**DATE:** 02.20.2018  
**TO:** ProTrak  
**FROM:** Mitesh Baxi, Traffic Engineering  
Bill McDow, Transportation Planning

■ **COASTAL FINANCE OFFICES [TRC Plan Review #2]**

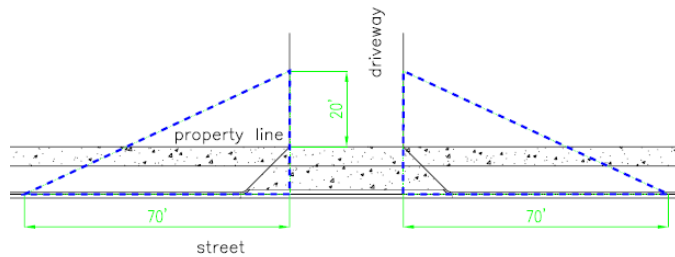
The proposed NCDOT driveway does not properly tie into the existing curb inlet. The driveway will have to be reconfigured to meet SD 3-03.3 for commercial driveways. Revise the drawing then coordinate directly with City Engineering and NCDOT for the new driveway.
